ADDENDUM NO. 2

DPW Project #2023256

April 30, 2024

**DPW/UI – Ag Science Building HVAC Phase Two
University of Idaho
Moscow, Idaho**

SHEET
T4.01

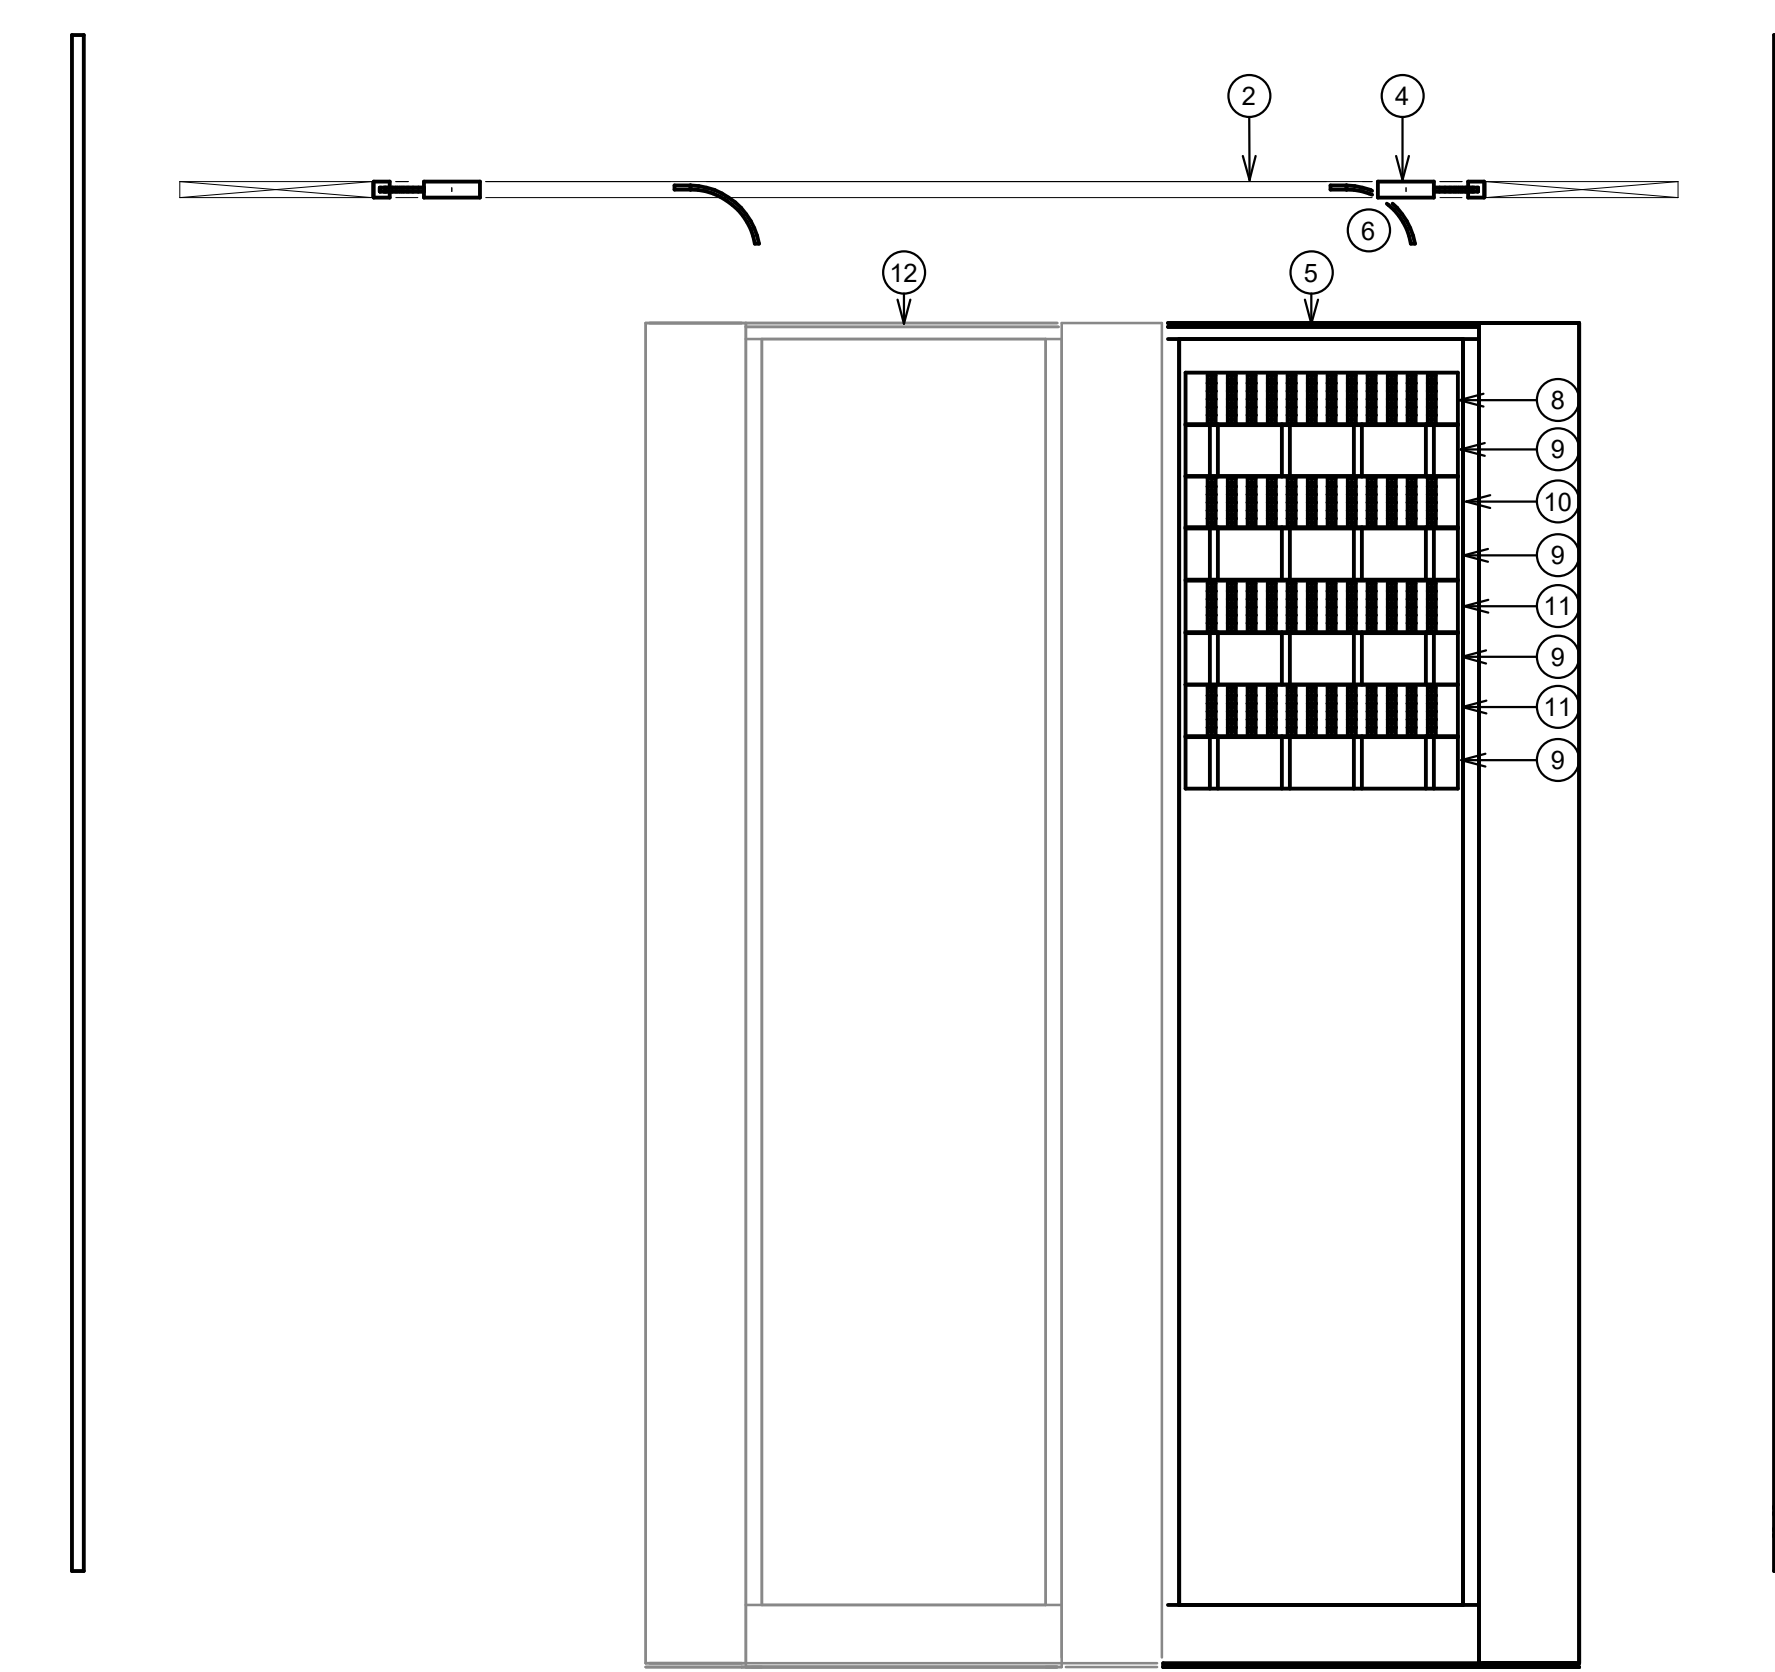
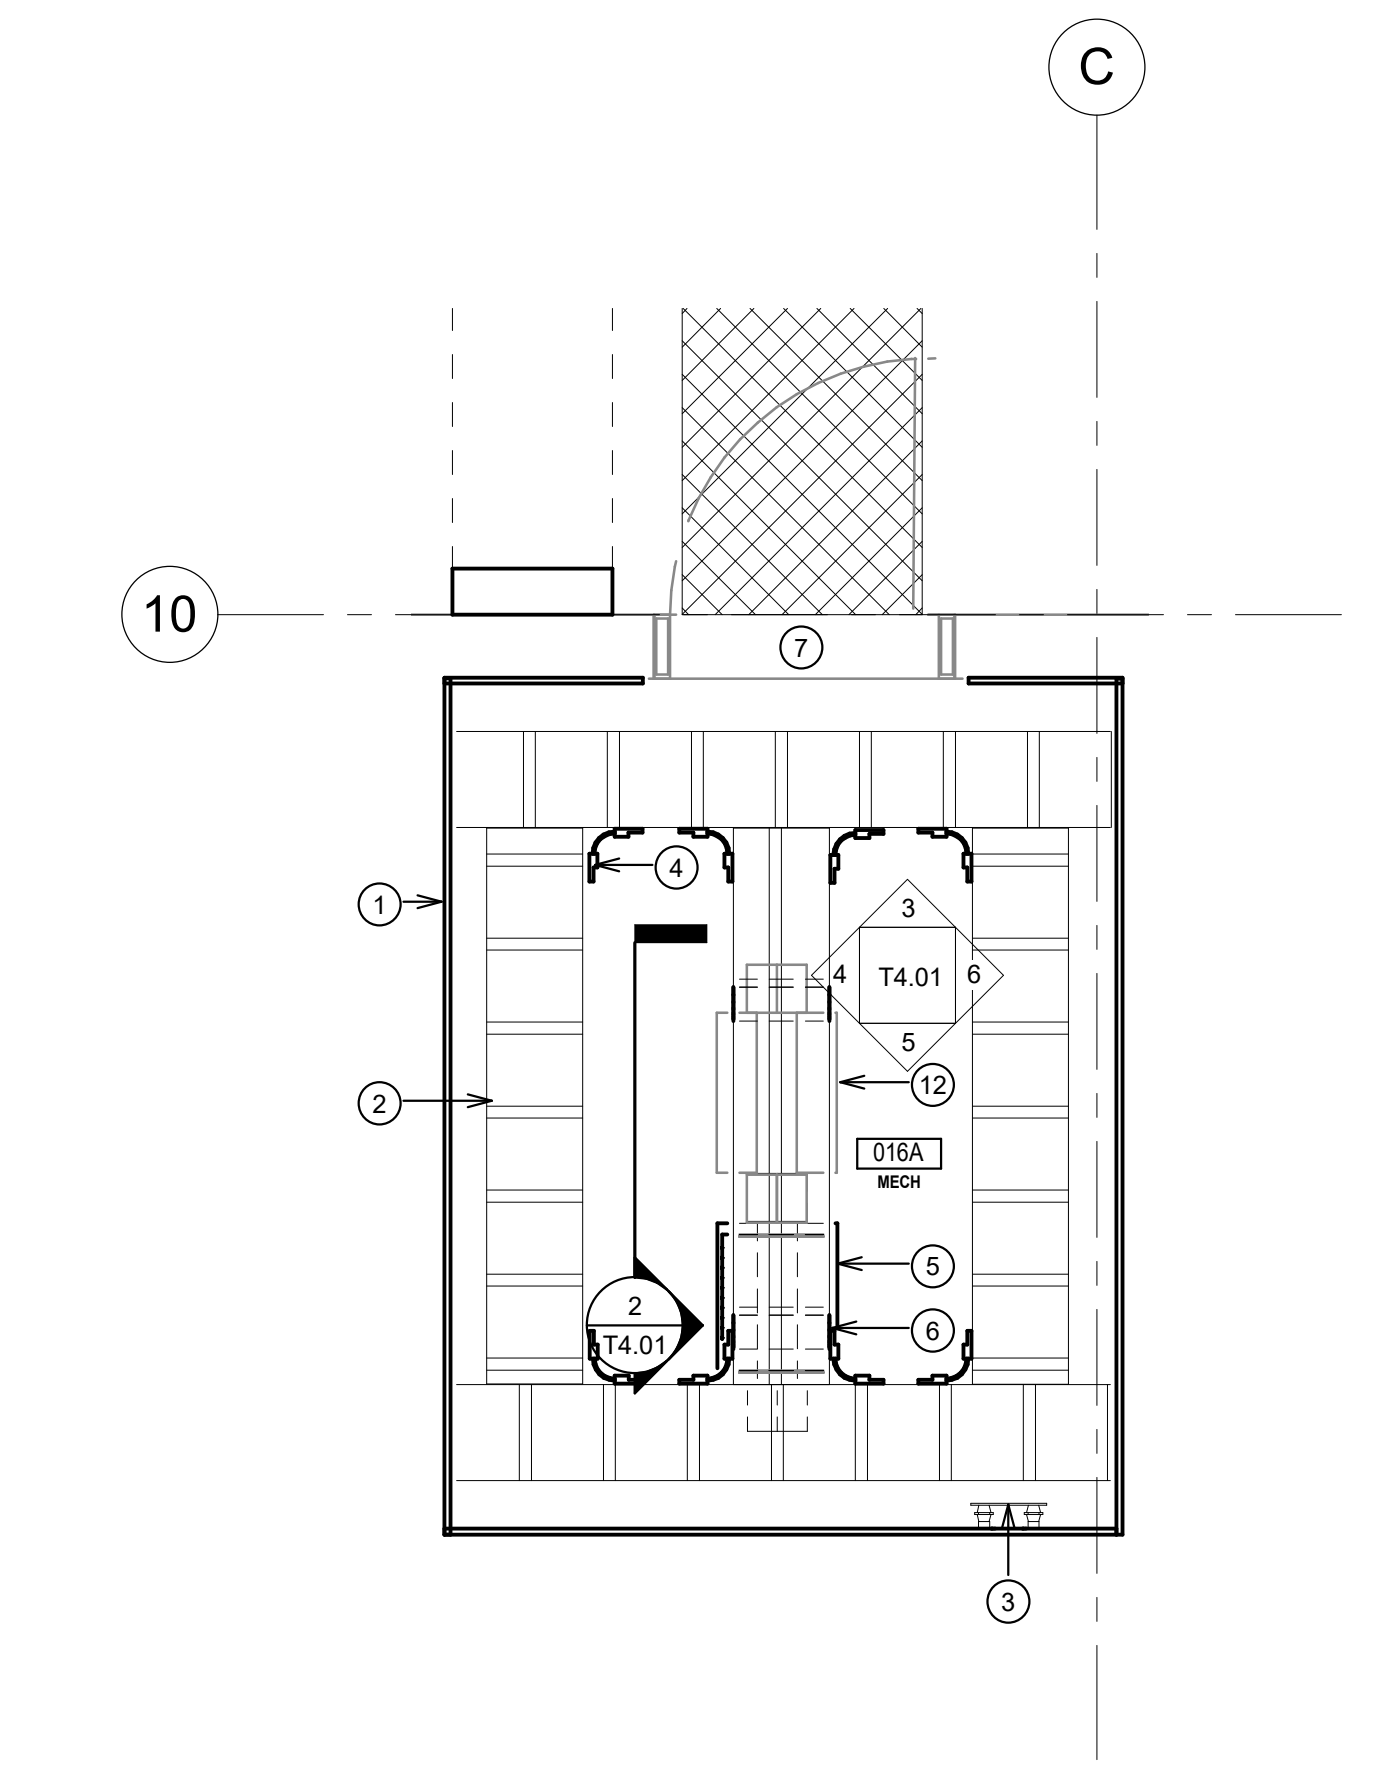
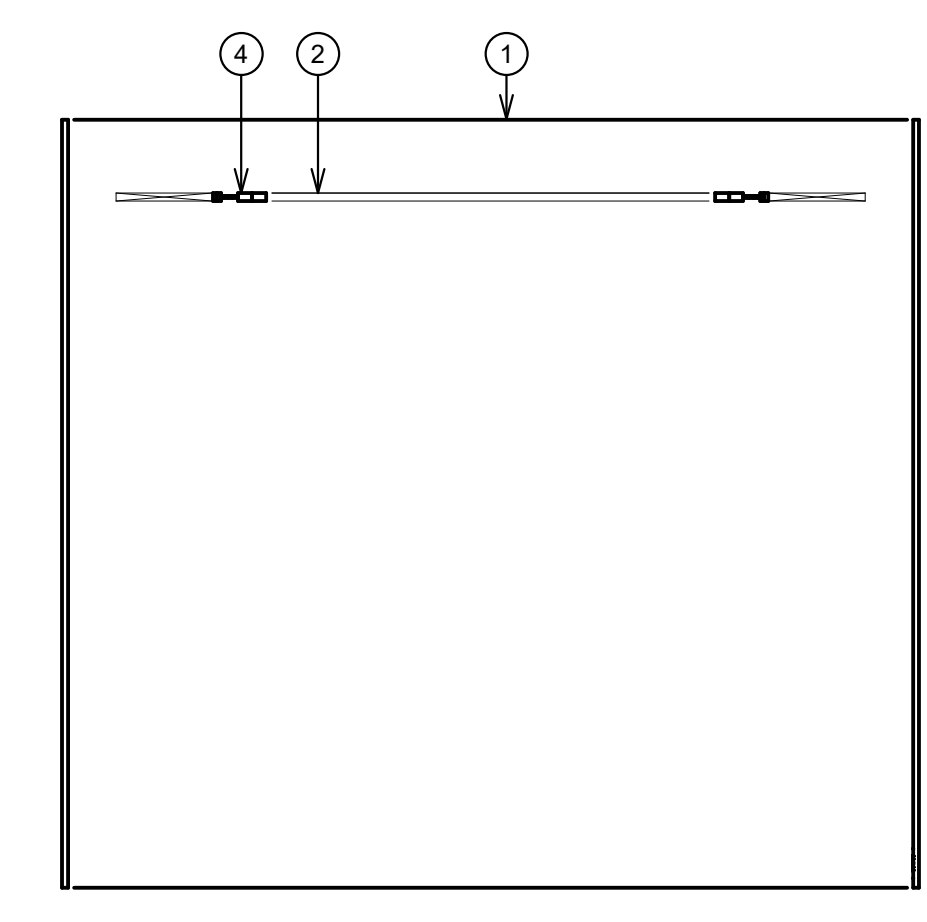
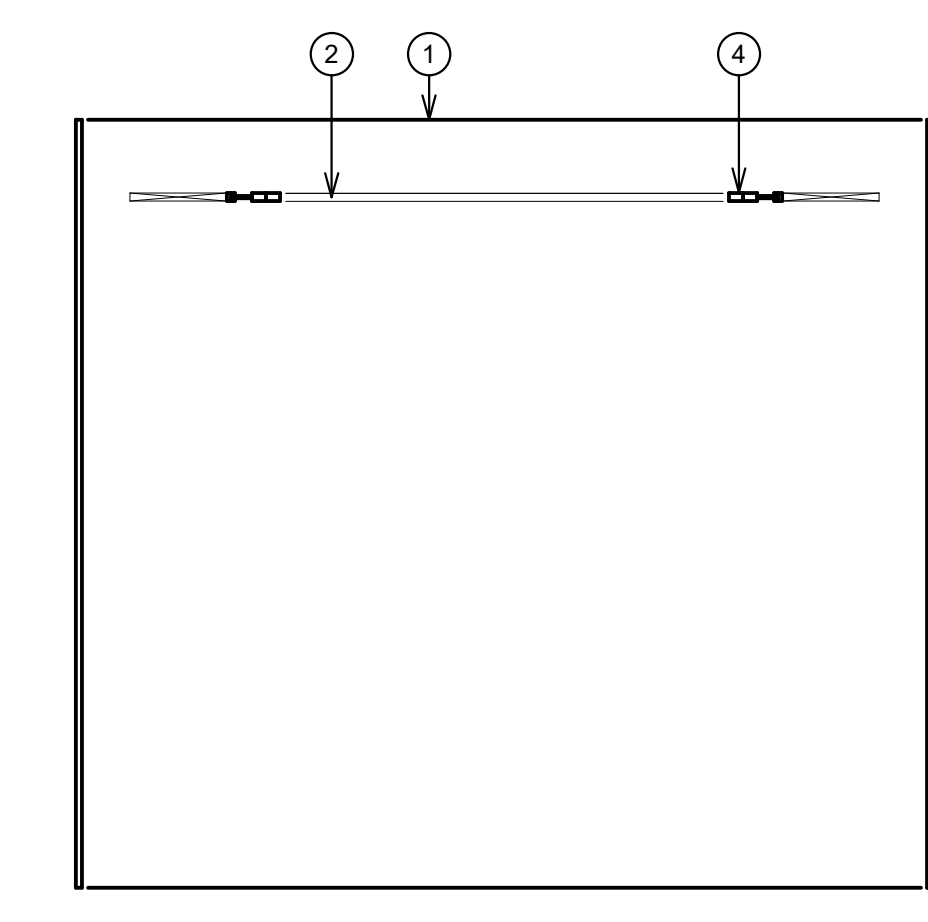
ADDITION: Added new telecom room layout for 016A Telecom Room. See attached drawing.

ADDITION: Added new elevation view of new racks for 016A Telecom Room. See attached drawing.

ADDITION: Added enlarged view of existing MDF located in the main electrical room B01 in the basement. See attached drawing.

ADDITION: Added (4) new rack elevations of the new telecom room in 016A Telecom Room. See attached drawing.
